In the Drawings:

In compliance with the Examiner's requirements, Applicant submits a set of marked-up informal drawings with proposed added legends for various boxes in each drawing. This set of drawings is informal and the added legends should be helpful to the examination of the application by showing the actual device name of each box.

Fig. 5

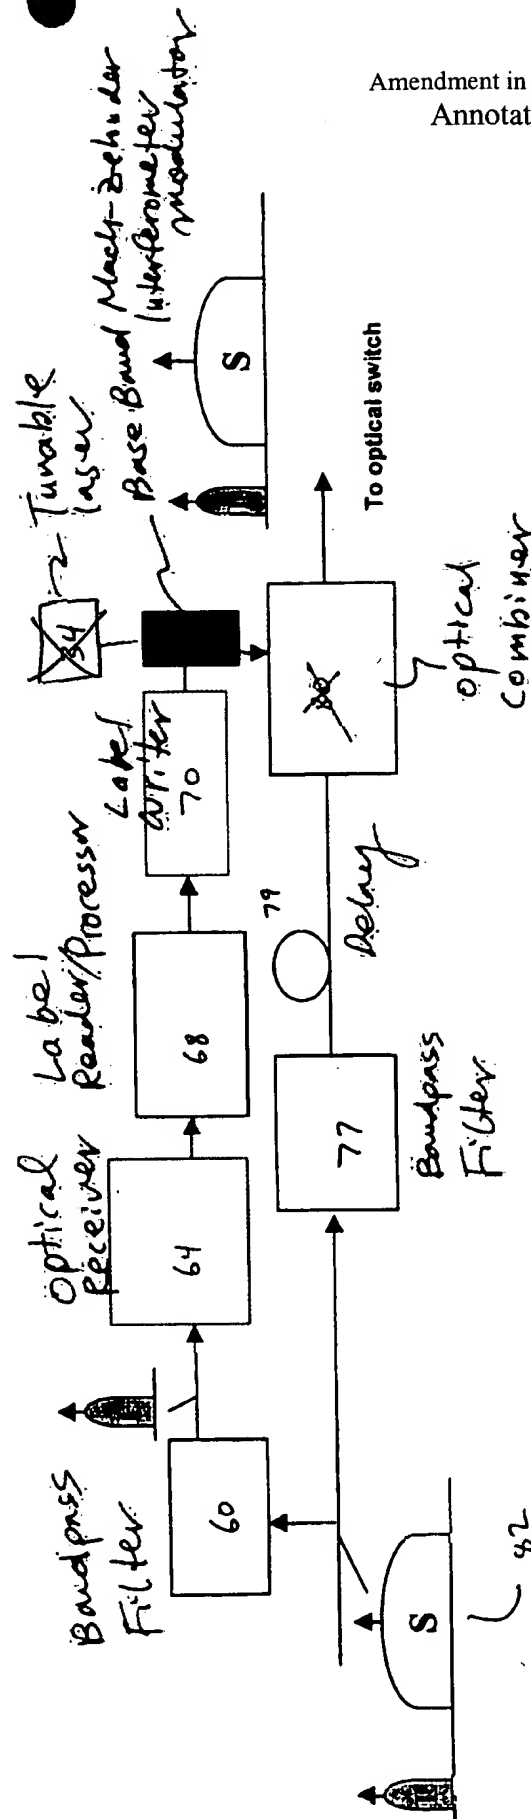
FIG. 5 as originally filed appears to have incorrect numerals and have been corrected in the proposed drawings. Specific details for corrections in FIG. 5 are as follows.

The box "34" should be labeled with a different numeral number because this box is described as a tunable laser on page 13, lines 10-11 of the original specification. Hence, Applicant proposes to remove the numeral "34" and label it as "tunable laser" as marked in red.

The box underneath the box originally labeled as "34" should be a base band Mach-Zehnder interferometer modulator according to the textual description on page 13, lines 10-11 of the original specification. Accordingly, this box is proposed to be labeled as "base band Mach-Zehnder interferometer modulator."

It appears that the box "77" is not explicitly described in text in the original specification. However, based on the description for FIGS. 5 and 6 on page 13 and the description on other implementations in the original specification, it can be readily inferred that the box "77" represents a bandpass filter that rejects a channel "L" having the label information and passes the signal channel "S" having data. Accordingly, the box "77" has been labeled as such and additional text has been proposed to add in the paragraph beginning on page 13, line 4 to reflect this.

Finally, the box originally labeled as "80" should be an optical combiner to combine the signal optical wave without the original label signal and the optical signal with the new label information produced by the base band Mach-Zehnder interferometer modulator. This can be readily inferred from the original specification. Since the numeral "80" is already designated as an optical modulator in FIG. 3(a), it is proposed that the numeral "80" be removed and replaced with a text label of "Optical Combiner" as marked in red in the amended FIG. 5.
